Access Compliance Report

Public Rights-of-Way

Intersection ID: 2478	Main Street: WHISTLER'S_CHASE_DR	Cross Street: HIGHLAND_CREEK_PY	Location: W
ADA ID: 30B8B5541005	Ramp Type: PerpDiag	Initial Pass/Fail: Fail	Overall Compliance: No
		Severity Score: 22.5

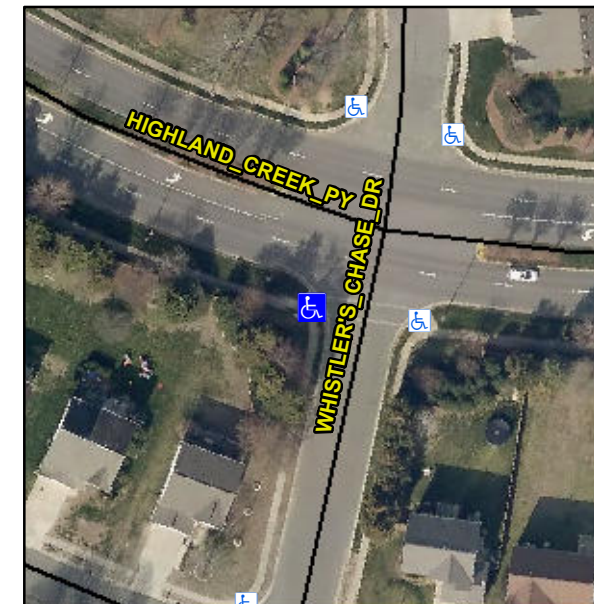
R304.5.1, R304.2.2, R304.5.3

Compliance	Description	Data	Compliance	Description	Data
N/A	Ramp Length (in)	57.5	No	Ramp Slope (%)	9.6
No	Ramp Width (in)	41.5	No	Ramp XSlope (%)	3.7
N/A	Flare Type LT	N/A	N/A	Flare Type RT	N/A
N/A	Flare Slope LT (%)	N/A	N/A	Flare Slope RT (%)	N/A
N/A	Flare Traversable LT?	N/A	N/A	Flare Traversable RT?	N/A
N/A	Landing Length (in)	N/A	N/A	DWS Provided?	N/A
N/A	Landing Width (in)	N/A	N/A	DWS Contrast?	N/A
N/A	Landing Slope (%)	N/A	N/A	DWS Length (in)	N/A
N/A	Landing X Slope (%)	N/A	N/A	DWS Full Width?	N/A
N/A	Landing Curb? (Y/N)	N/A	N/A	DWS Offset (in)	N/A
N/A	Shared Landing?	N/A			
N/A	Gutter Ponding?	N/A	N/A	Gutter Slope (%)	N/A
N/A	Gutter Lip Ht (in)	N/A	N/A	Gutter X Slope (%)	N/A
N/A	Painted X Walk1?	Yes	N/A	Painted X Walk2?	No
	X Walk 1 Direction	To SE		X Walk 2 Direction	To NE
N/A	X Walk 1 Width (in)	97.0	N/A	X Walk 2 Width (in)	N/A
	X Walk 1 Slope (%)	5.6		X Walk 2 Slope (%)	5.8
	X Walk 1 X Slope (%)	4.5		X Walk 2 X Slope (%)	4.3

Remove & Replace Curb Ramp With Two New Directional Ramps or Equivalent.
